November 2, 2016

**Reference: Sunoco Pipeline L.P. – Pennsylvania Pipeline Project
Act 167 Stormwater/Floodplain Management Program Consistency Request-
UPDATED Project Workspaces**

Enclosures: Updated Site Plan/Floodplain Maps

Sheet 48 Scale 1:2400

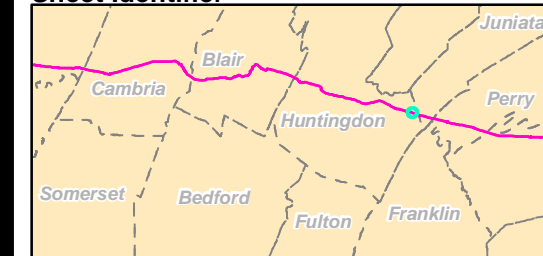
Consistent with the letter we previously sent, no aboveground facilities and no new access roads are proposed in FEMA designated floodways or 100-year floodplains. A new block valve and associated permanent access road have been sited outside any floodplains east of Shade Valley Road (Sheet 48). The Project pipeline ROW would continue to cross designated FEMA Special Flood Hazard Area Zone A. However, some of these areas would be crossed using horizontal directional drill or boring techniques, reducing surface disturbance and potential Project impacts. Nonetheless, the entire pipeline will be buried and preconstruction contours and elevations will be restored following pipeline installation.
